ARMY ENGINEER DISTRICT ST LOUIS MO
NATIONAL DAM SAFETY PROGRAM. MADDOX LAKE DAM (MO 30024). LOWER --ETC(U)
AUG 78

Maddox Lake Dam (MO 30024), Lower
 Mississippi - St. Francis Basin, Wayne
 County, Missouri. Phase I Inspection Report.

Name of Dam	Maddox Lake Dam
State Located	Missouri
County Located	Wayne County
Stream	Unnamed tributary to Rings Creek
Date of Inspection	10 & 11 July 1978

PLATE 3

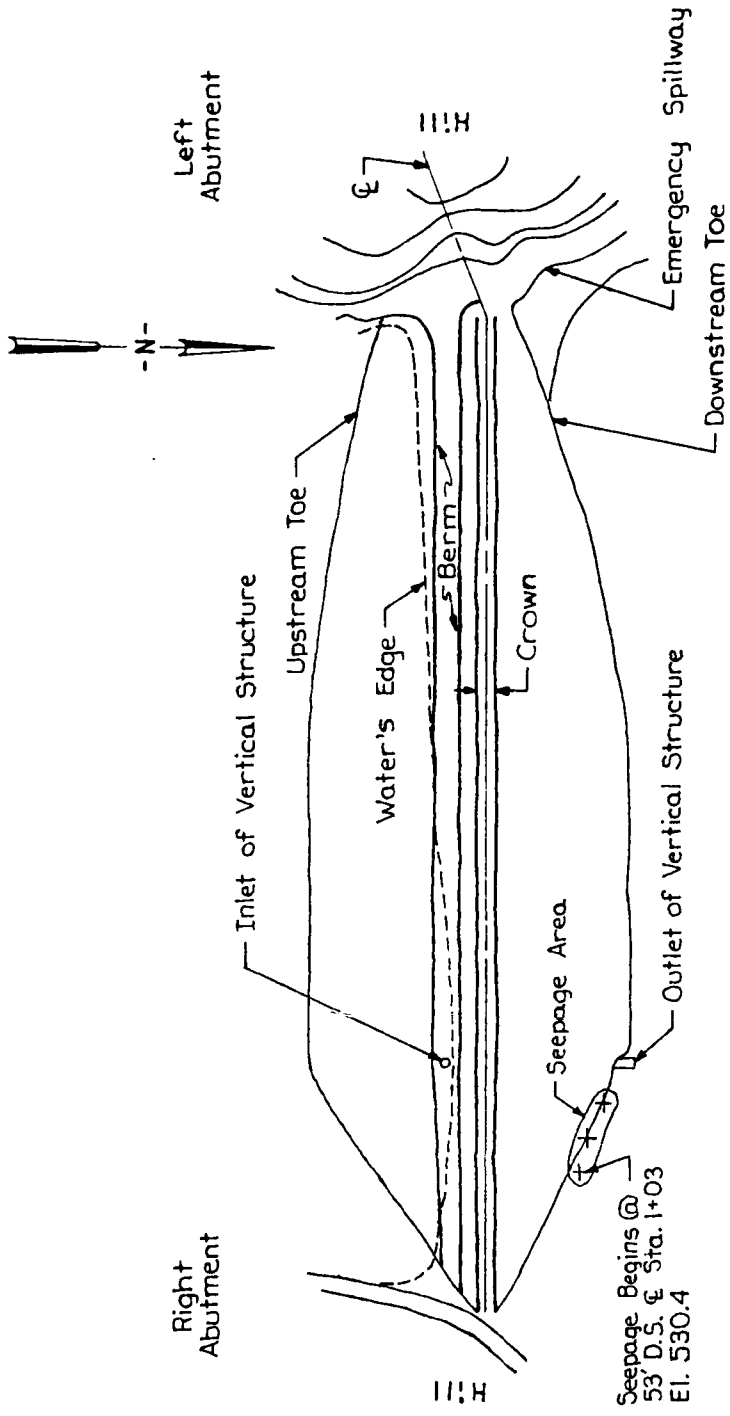
Seepage was observed flowing at an estimated 5 gpm from the right abutment in the area shown on Plate 3. The seep water was reddish in color, indicating flow through a high iron content soil (see Photo 5) and had a temperature of 63°F. The owner of the dam stated that before the dam was constructed, a spring flowed from this area with reddish water and another spring flowed from an area approximately 500 feet downstream of the right abutment. He also stated that there are iron deposits in the hill which the right abutment adjoins. The downstream spring was located flowing from the hill with clear water having a temperature of 70°F. A temperature profile of the lake was performed with the following results:

Seepage Begins @
53' D.S. & Sta. 1+03
El. 530.4

- (1) Cut the bushes and trees growing on the downstream slope.
- (2) Check the downstream slope periodically for seepage. If seepage flows are observed, the dam should be inspected and the situation evaluated by an engineer experienced in design and construction of dams.
- (3) A detailed inspection of the dam should be made at least every 5 years by an engineer experienced in design and construction of dams.

CROSS-SECTION (STA. 1+65)
1966 DRAWINGS

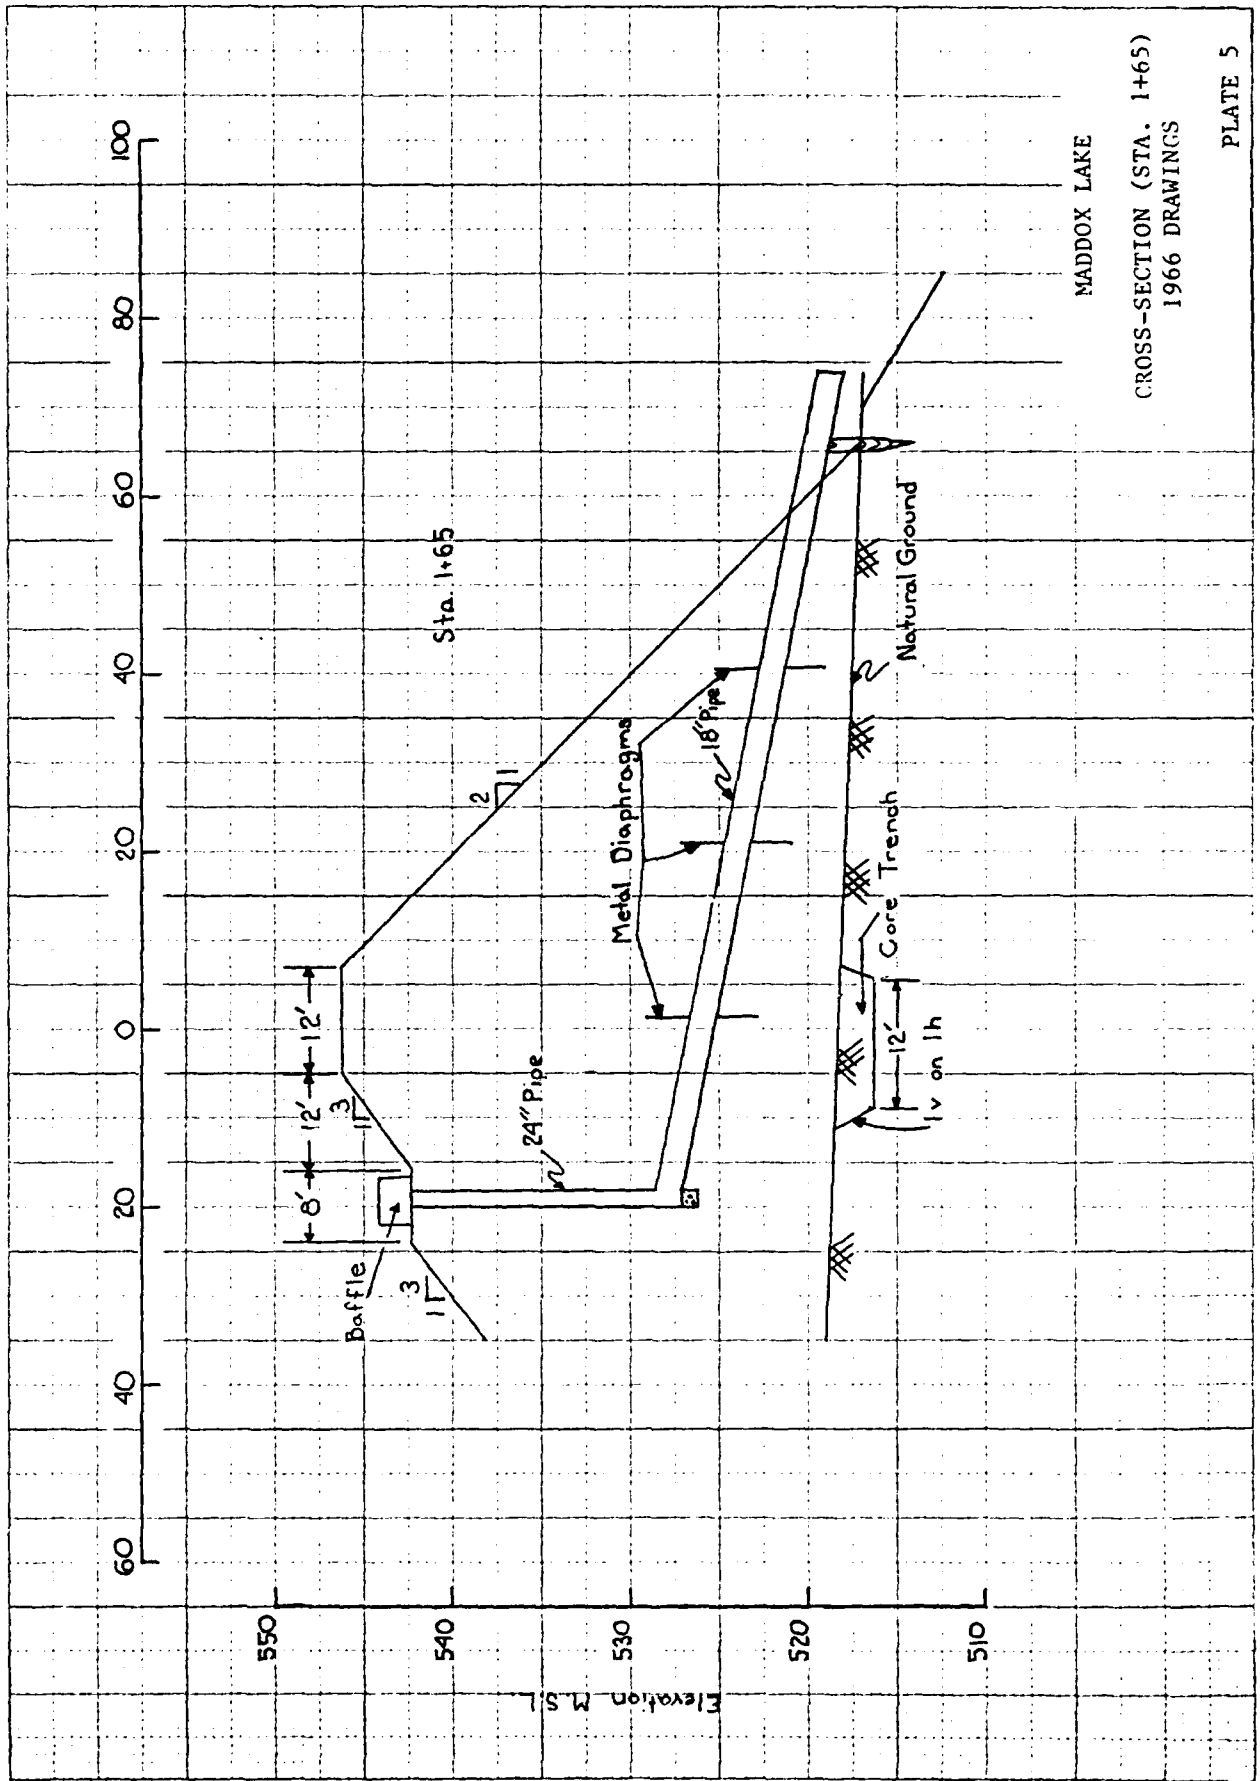
c. Validity. A portion of the hydrology and hydraulic design presented on the 1966 drawings appears to be erroneous. There seems to be an error in the elevation-discharge computations. The weir formula was used to calculate the flow ("weir flow") into the vertical inlet at low stages which is correct. However, the length of the weir is 6.28 feet rather than 19 feet as presented on the 1966 drawings. This results in a 66 percent reduction of the 1966 design calculated flow out of the lake by "weir flow". Also for routing purposes, the flow through the discharge pipe is governed by the hydraulic losses of "conduit flow" after a head of 1.1 feet covers the vertical outlet. As the head (or lake level) increases from 1.1 feet, the flow through the vertical inlet will be governed by "conduit flow." Erroneously, the 1966 computations show the flow into the vertical inlet governed by "weir flow". No routing exist on the 1966 drawings for flow through the emergency spillway since the incorrectly calculated vertical inlet discharges passed the design storm (25 yr. frequency) without utilizing the emergency spillway.

c. Dam. No detrimental settlement, cracking, slides or animal burrows were observed in or near the earth embankment. Typical existing cross-sections of the embankment are shown on Plate 6. These sections are consistent with the cross-section presented in the Soil Conservation Service 1966 drawings (see Plate 5) except the existing downstream slope is a 1V on 2.4H instead of the specified 1V on 2H. The dam embankment appears to be well maintained except for several 3 to 4-foot high bushes and trees growing on the downstream slope (see Photo 4).
